ADDENDUM NO. 1

NEW BUILDING FOR CELINA ELECTRICAL DEPARTMENT

CITY OF CELINA, OHIO

Project No. 220803.02

E-1

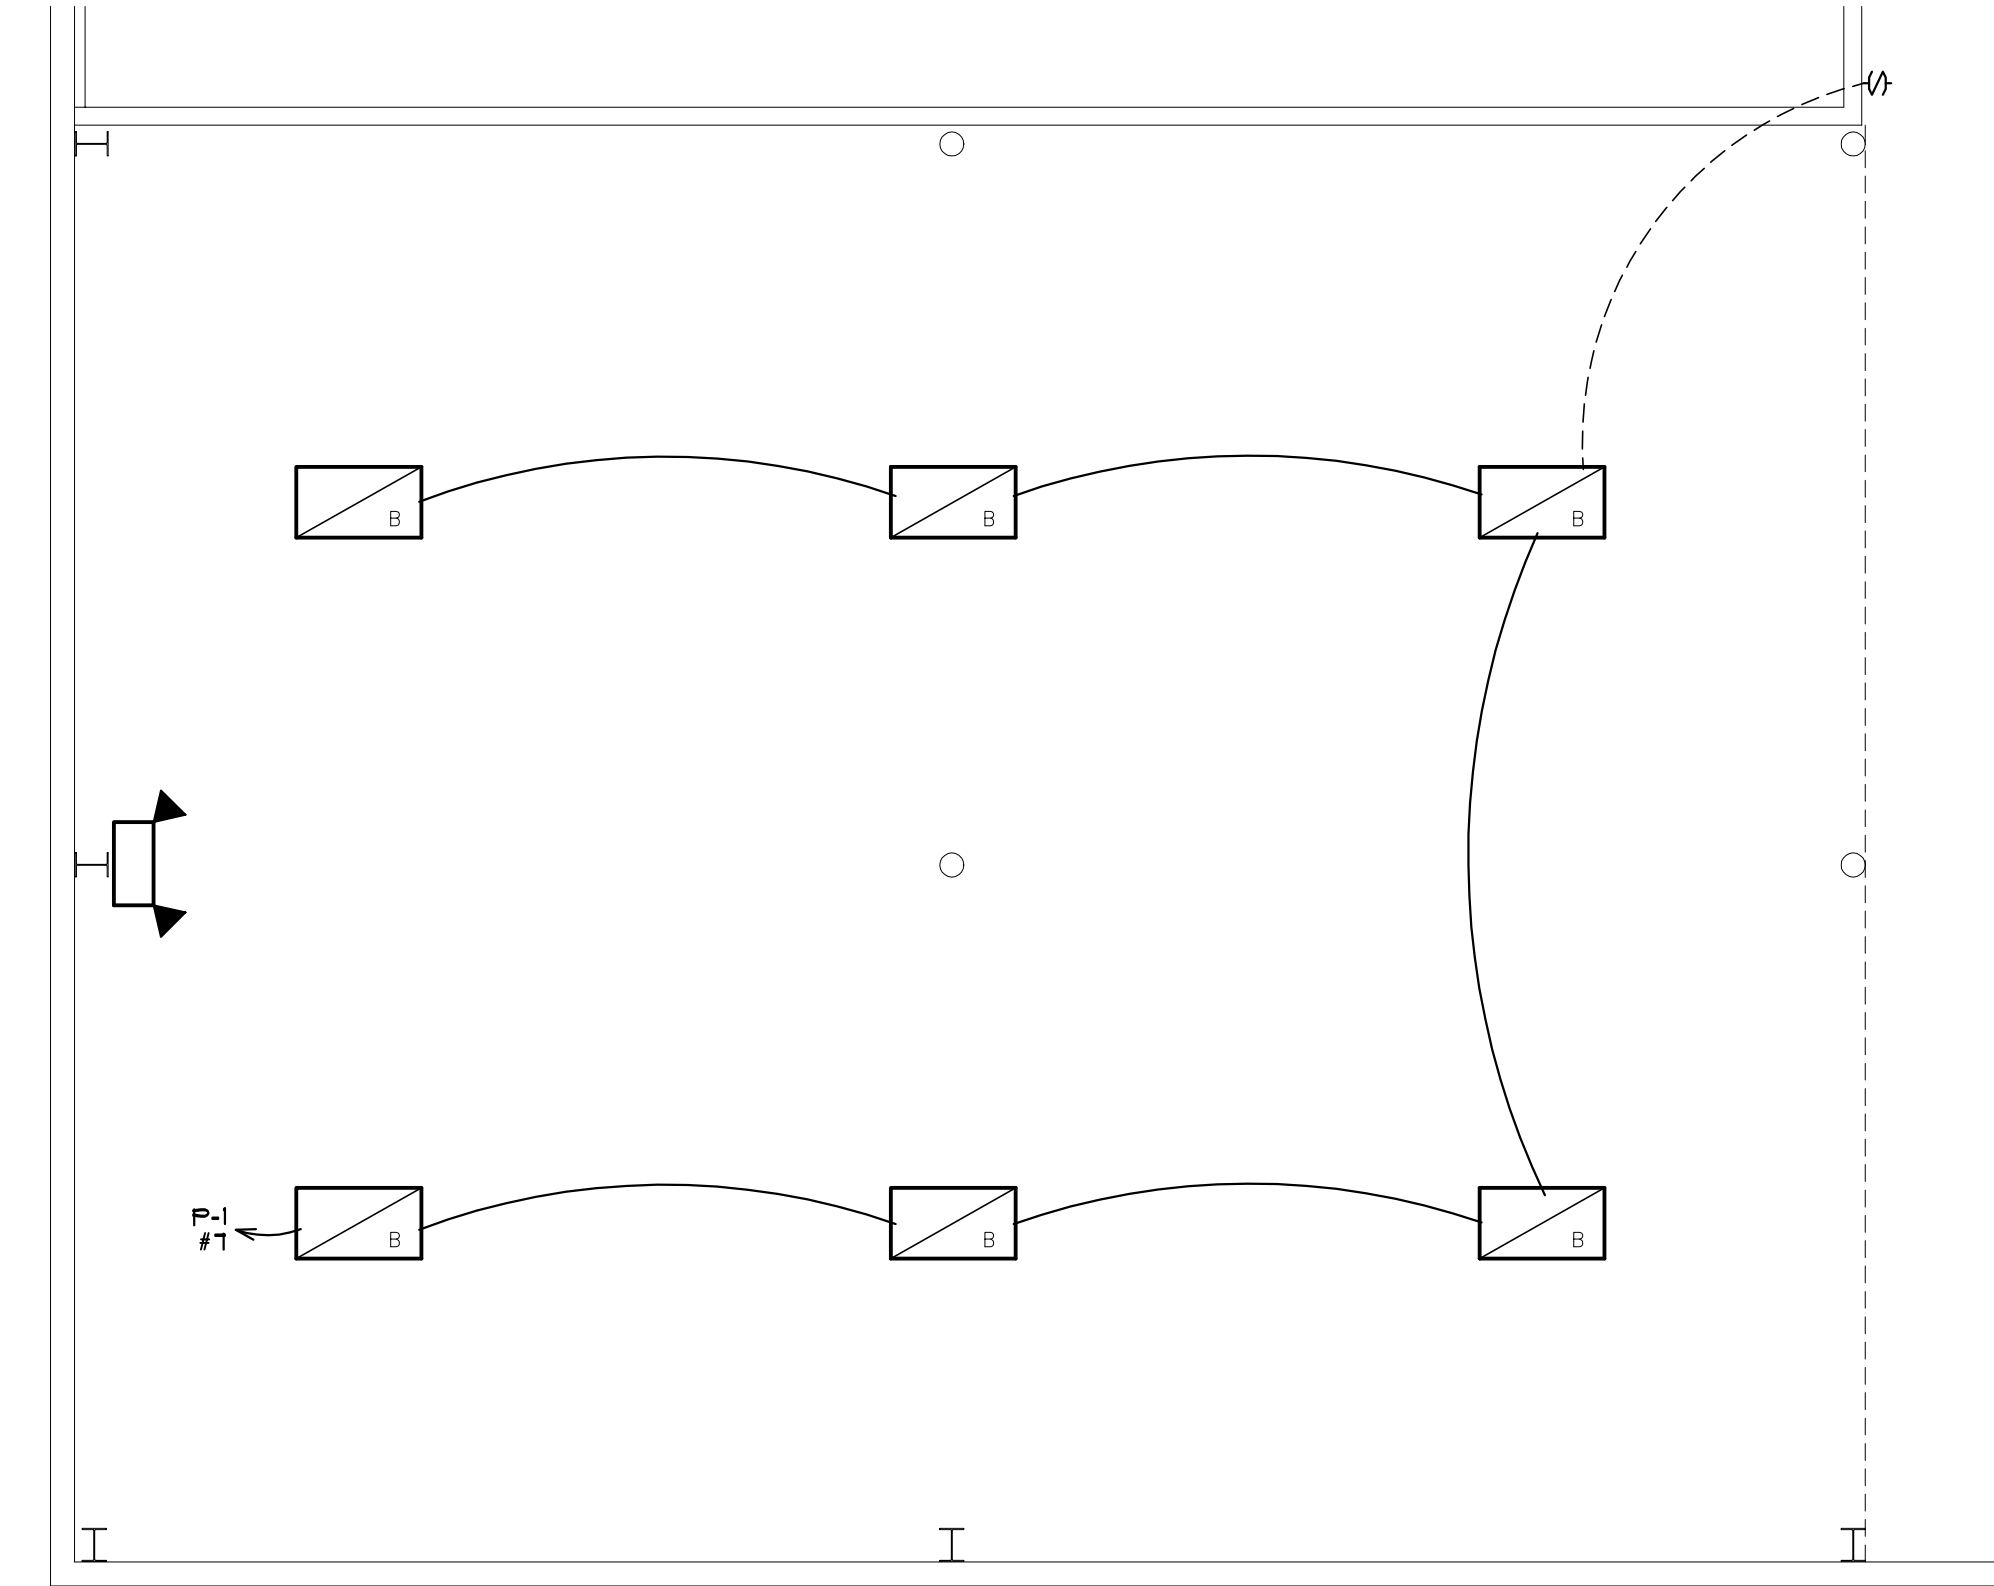
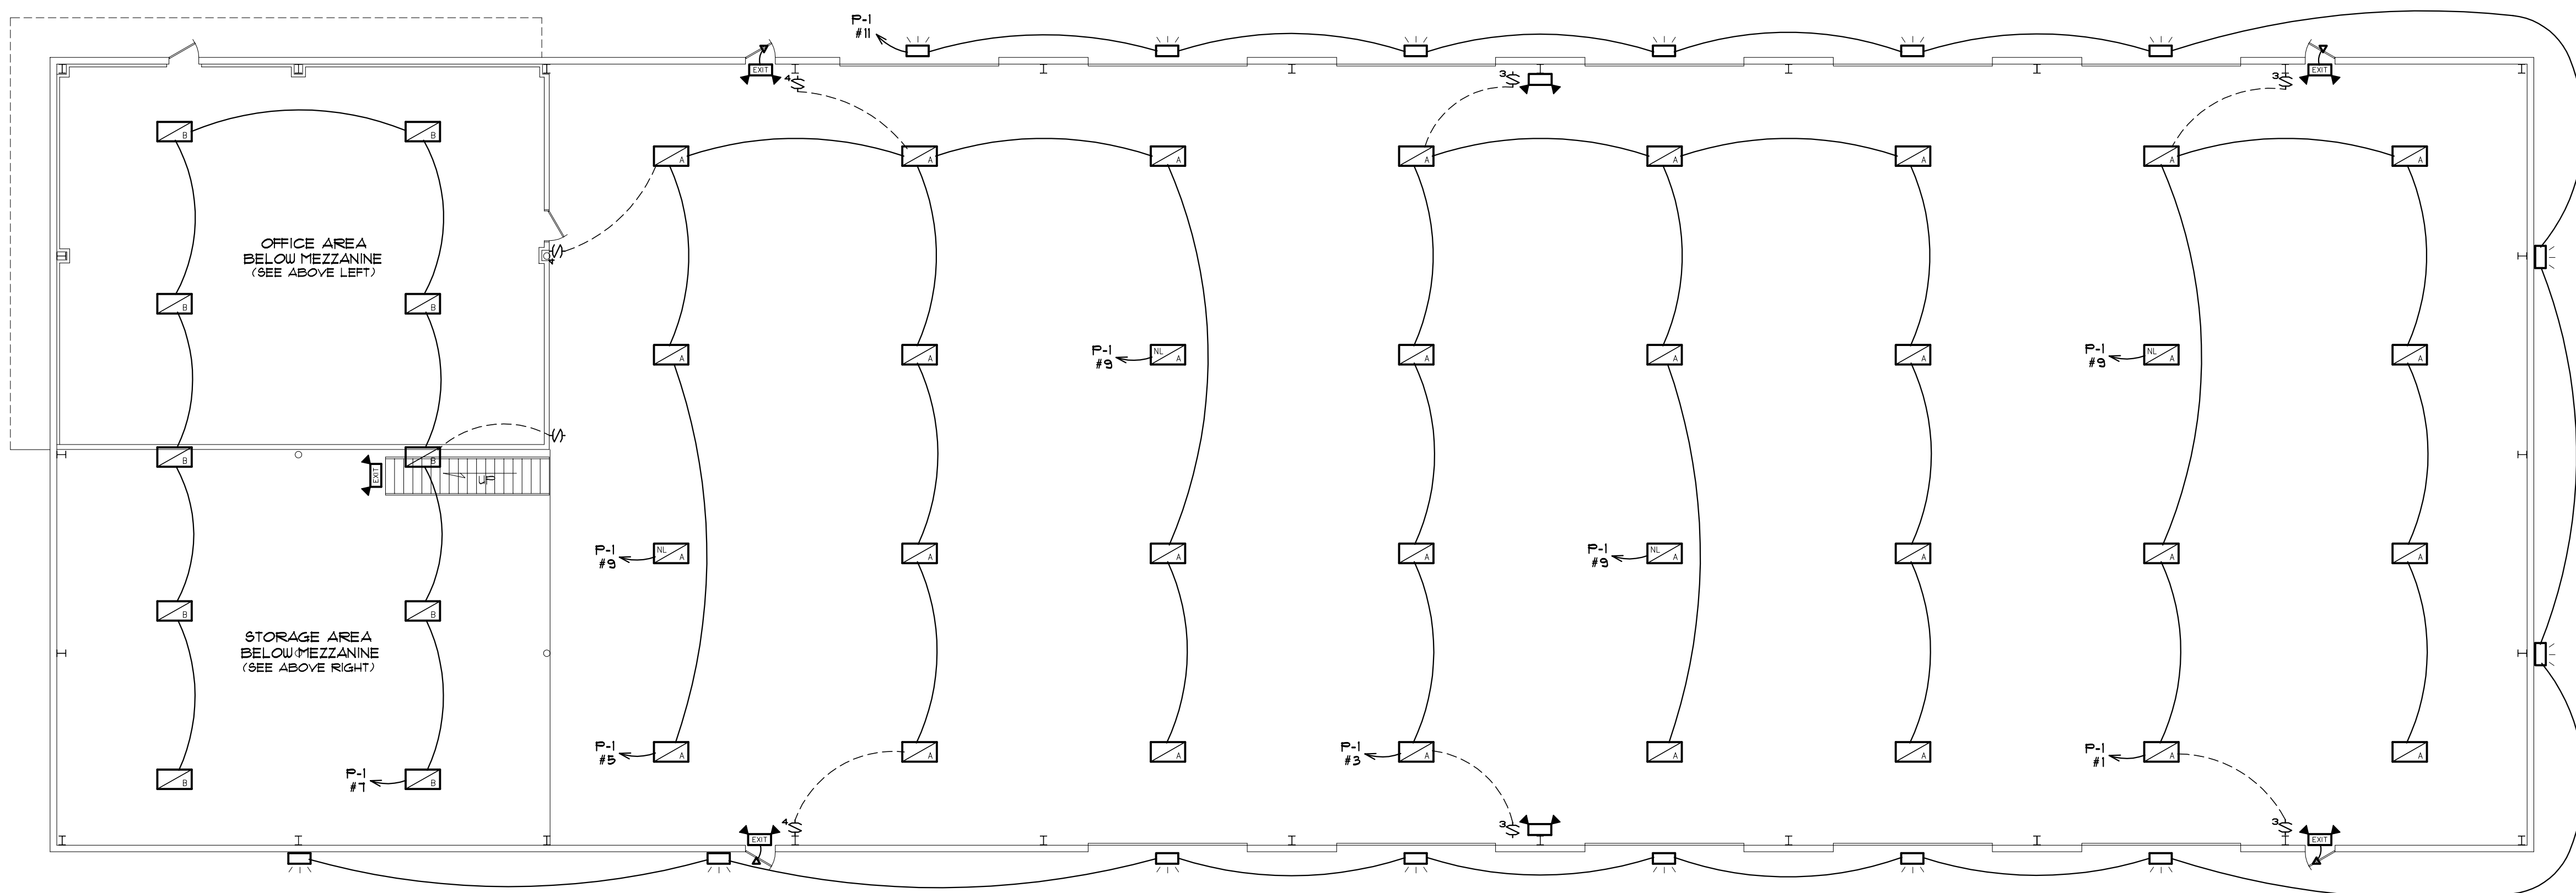
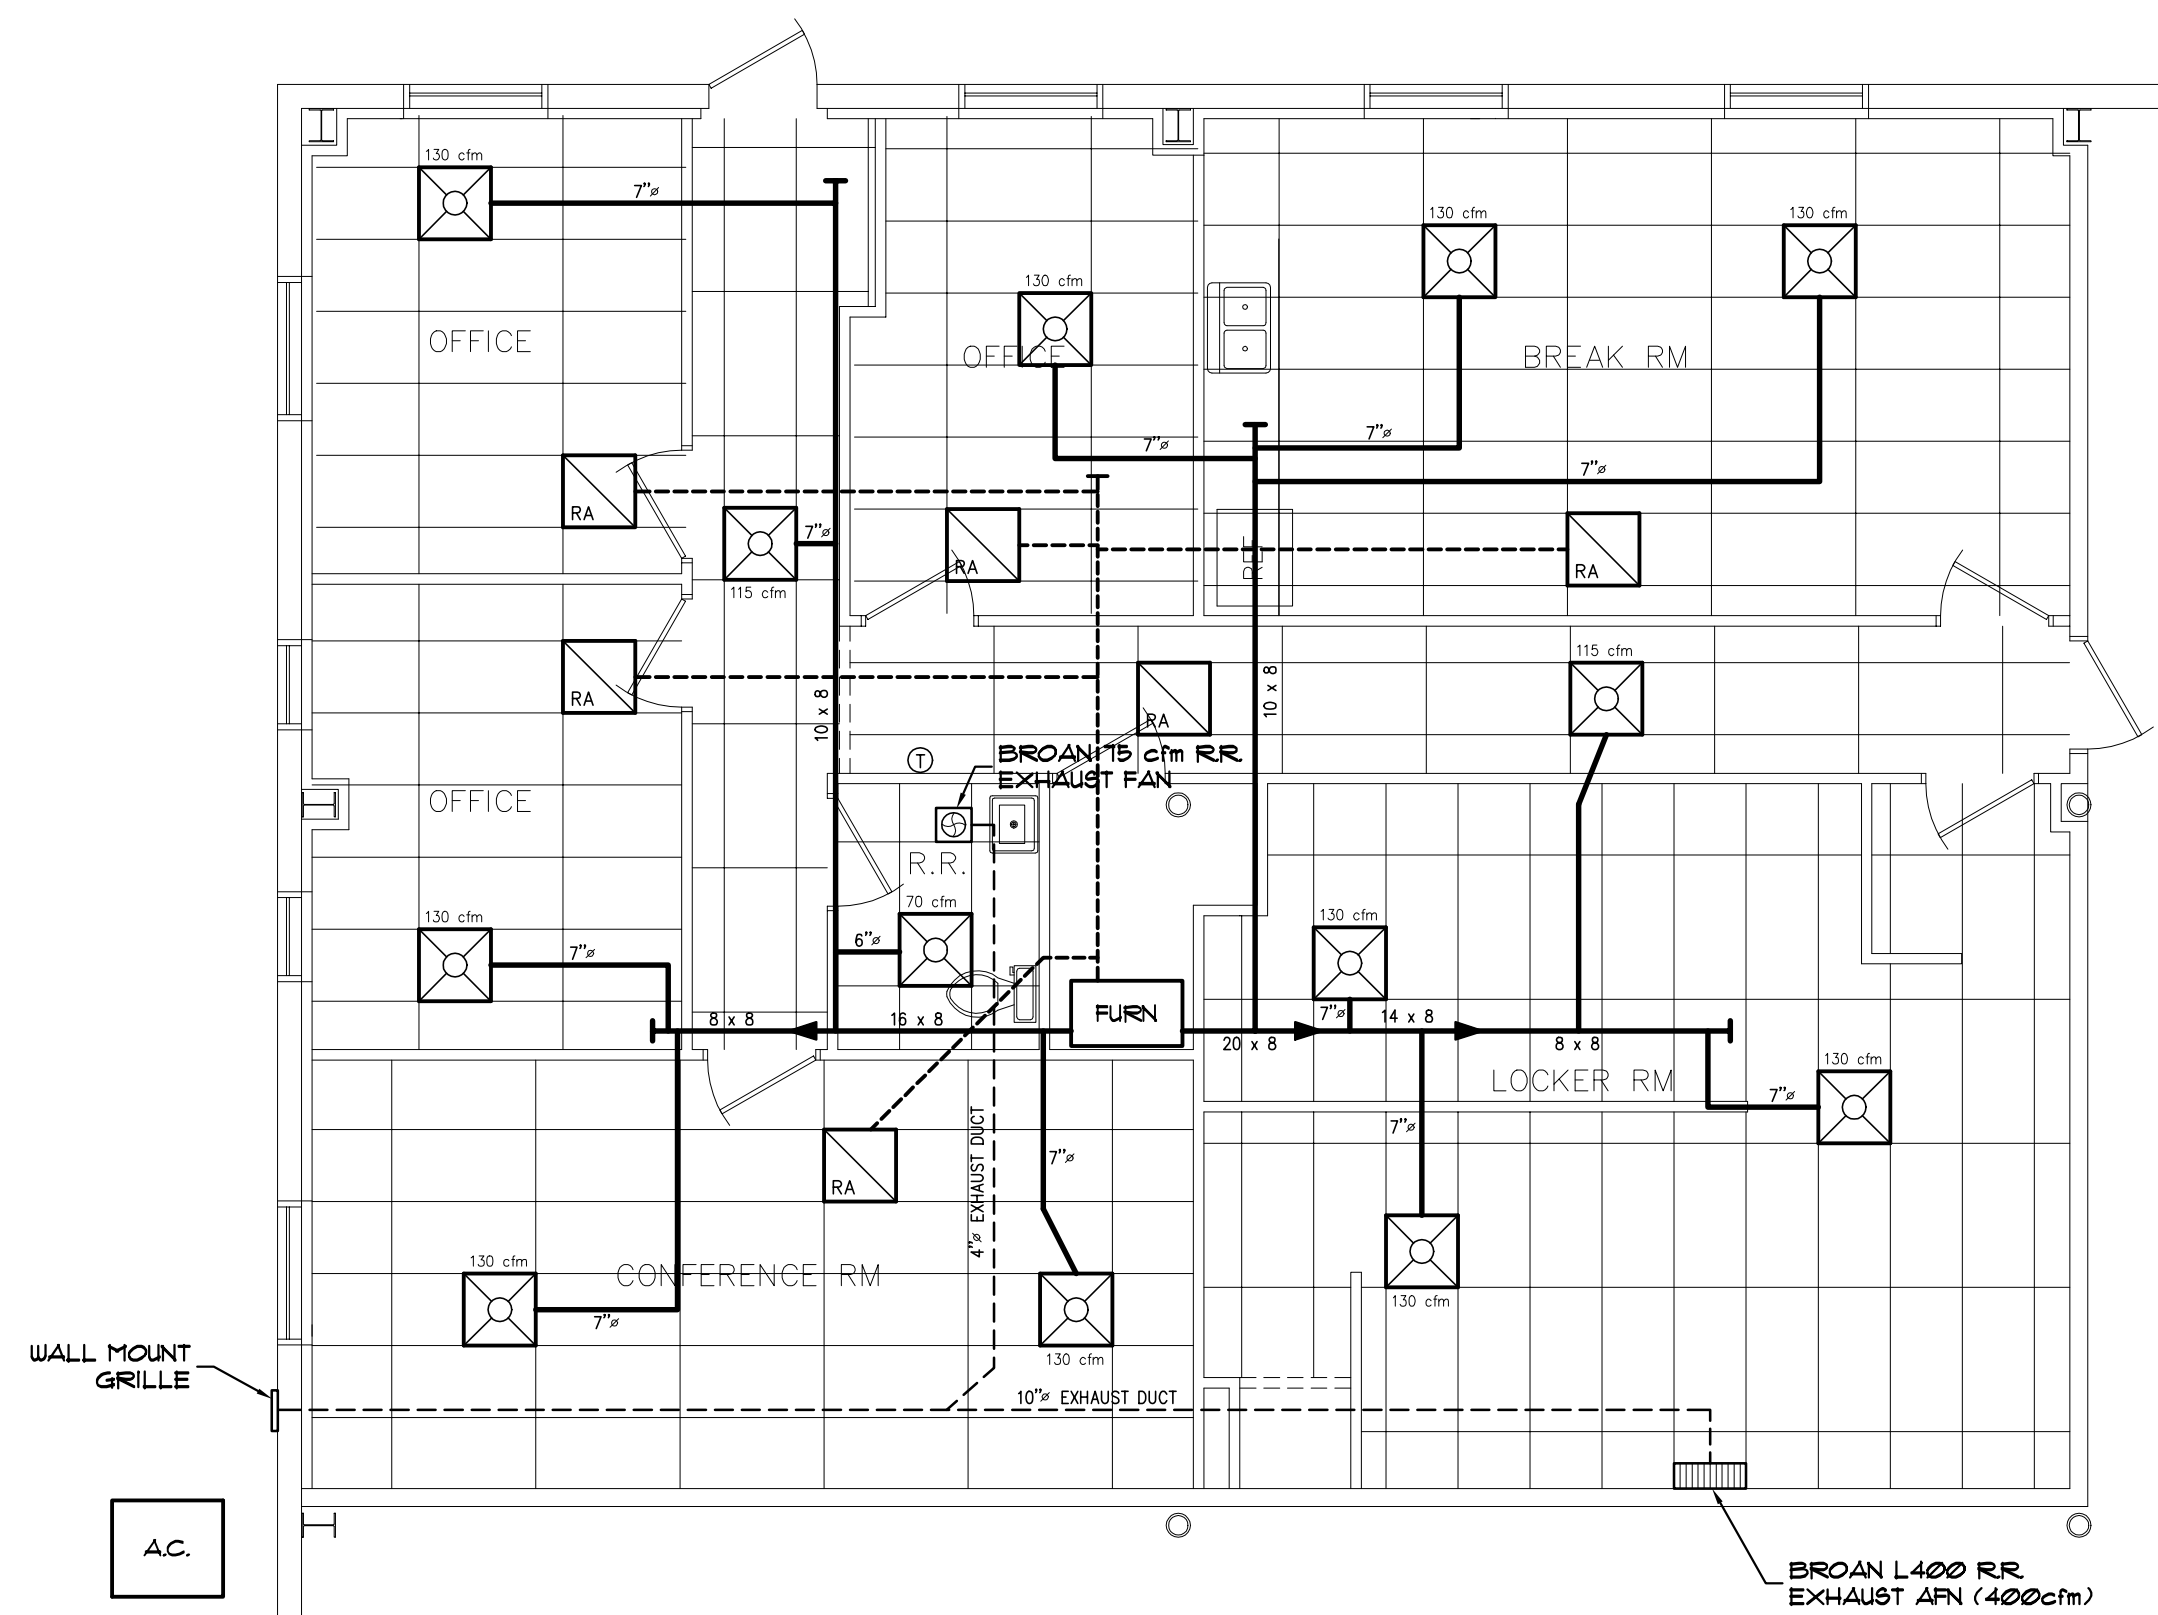
ITEM NO. 1 – Construction Drawings – Sheet E-1

- a) The attached revised Sheet E-1 drawing will replace the original drawing included in the bid documents. The revision to the drawing includes the addition of light switches.

△ LIGHT SWITCHES ADDED
